INNER WEST COUNCIL

DEVELOPMENT ASSESSMENT REPORT

Application No.	10.2019.177.1
Address	3 & 3A Haig Avenue, Summer Hill
Proposal	Subdivide the land into two (2) Torrens title allotments and alterations and additions to the existing dwellings
Date of Lodgement	20 November 2019
Applicant	Mr J Wong
Owner	Mr J Wong
Number of Submissions	Nil
Value of works	\$500,000.00
Reason for determination at Planning Panel	Clause 4.6 variation exceeds 10%
Main Issues	Lot size and heritage
Recommendation	Approved with Conditions
Attachment A	Recommended conditions of consent
Attachment B	Plans of proposed development
Attachment C	Clause 4.6 Exception to Development Standard
Attachment D	HCA statement of significance

01 PROPOSED SUBDIVISION PLAN 1:100
08

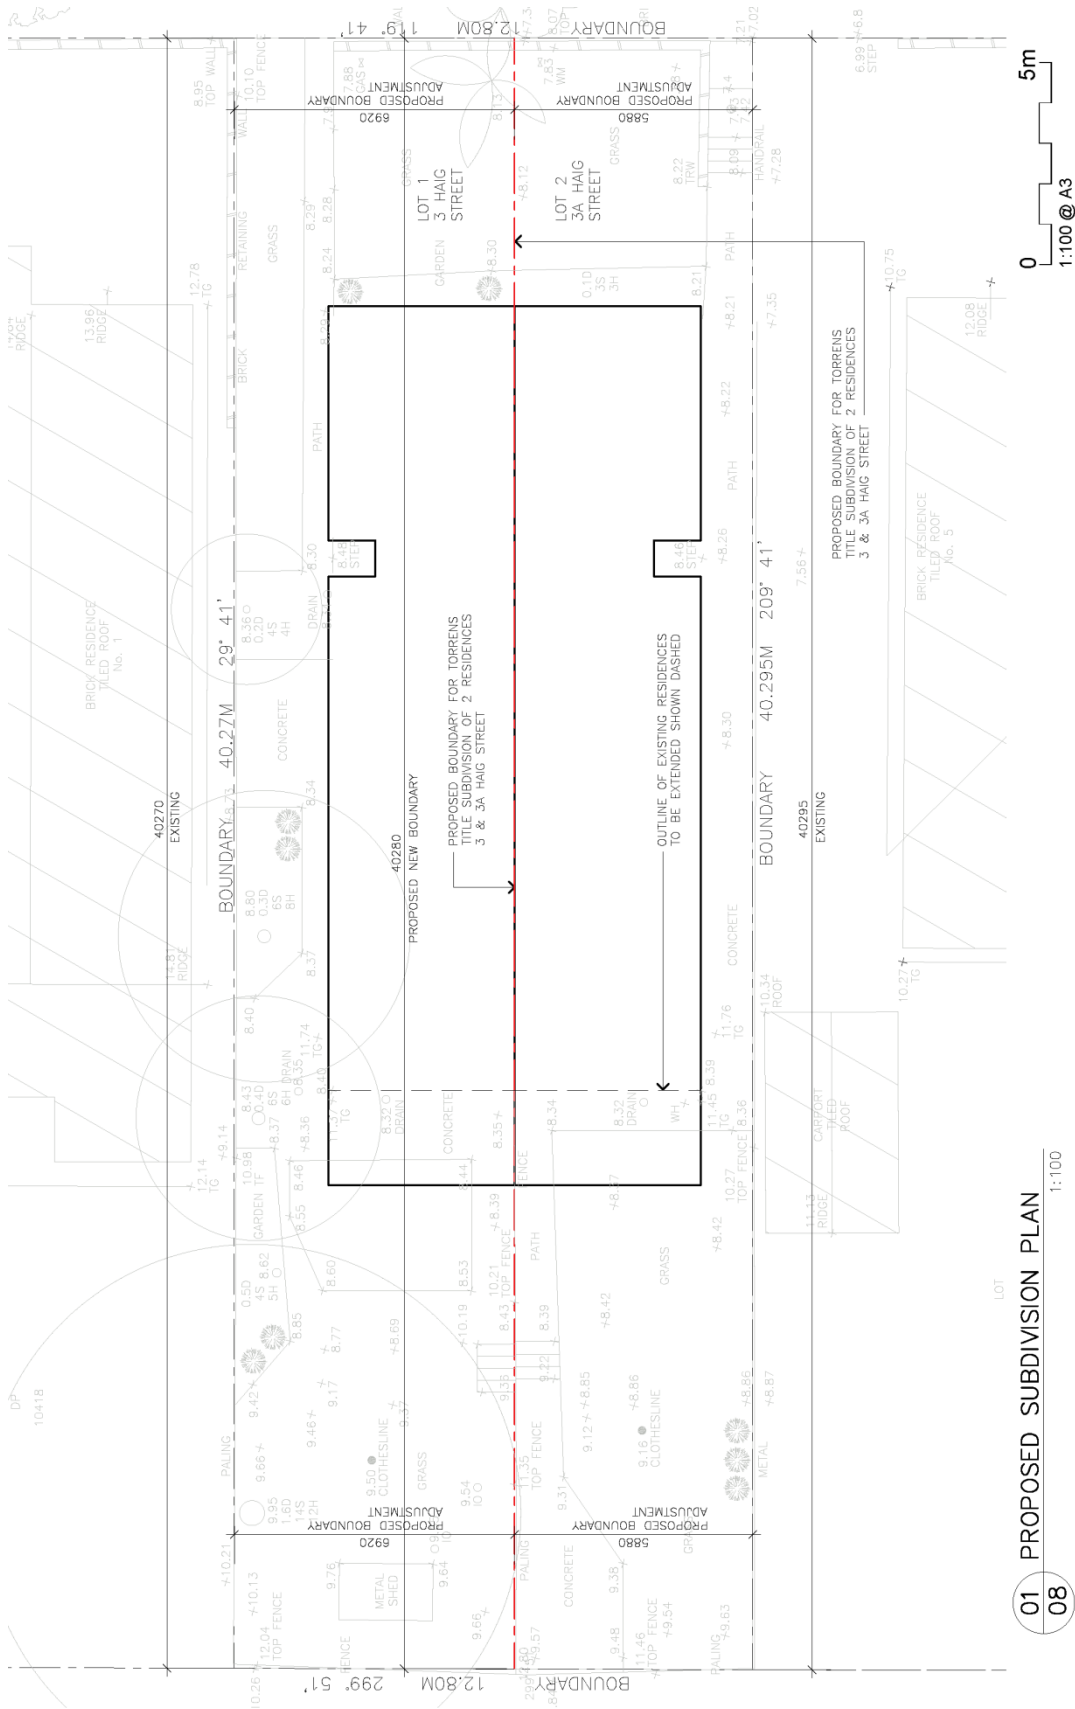
Clause 4.1(3) of ALEP 2013 specifies a minimum lot size of 500sqm for the site. The existing site has a total area of 515.6sqm. The application seeks to subdivide the site into two (2) lots of the following dimensions which do not meet the minimum lot size permitted:

The applicant seeks a variation to the minimum lot size development standard under Clause 4.6 of ALEP 2013 by 44.3% (221.33sqm) for Lot A and by 52.6% (263.07sqm) for Lot B.
